CPP CONTROL SYSTEM CONFIGURATION AND SYSTEM ARCHITECTURE DRAWING

PROJECT : CAPTIVE POWER PLANT, GURU GOVIND SINGH
REFINERY, BHATINDA.

Code-1 - with minor remarks
18/11/09

TITLE: CPP Control System Configuration & System Architecture Drawing

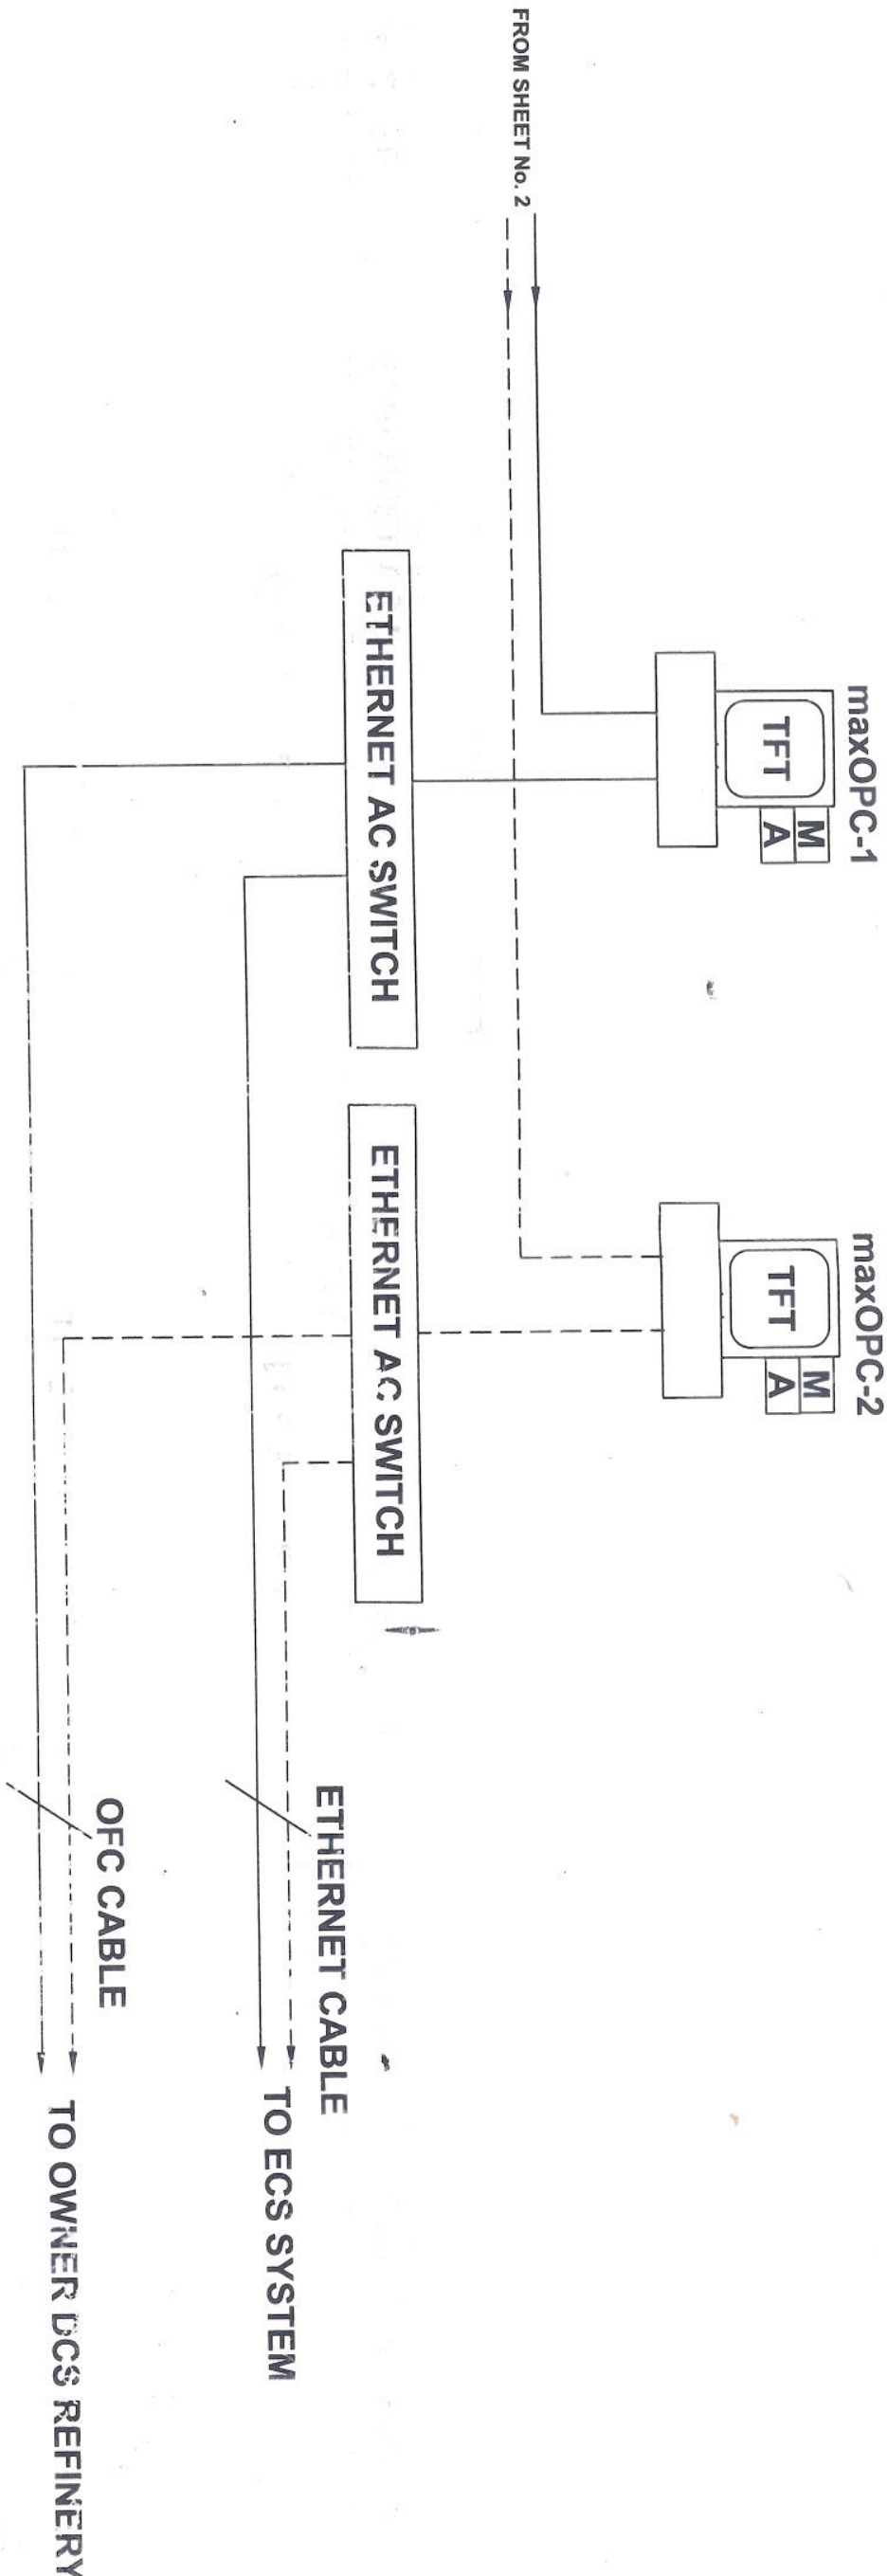
individual console configuration diagram for the submitted for each system.
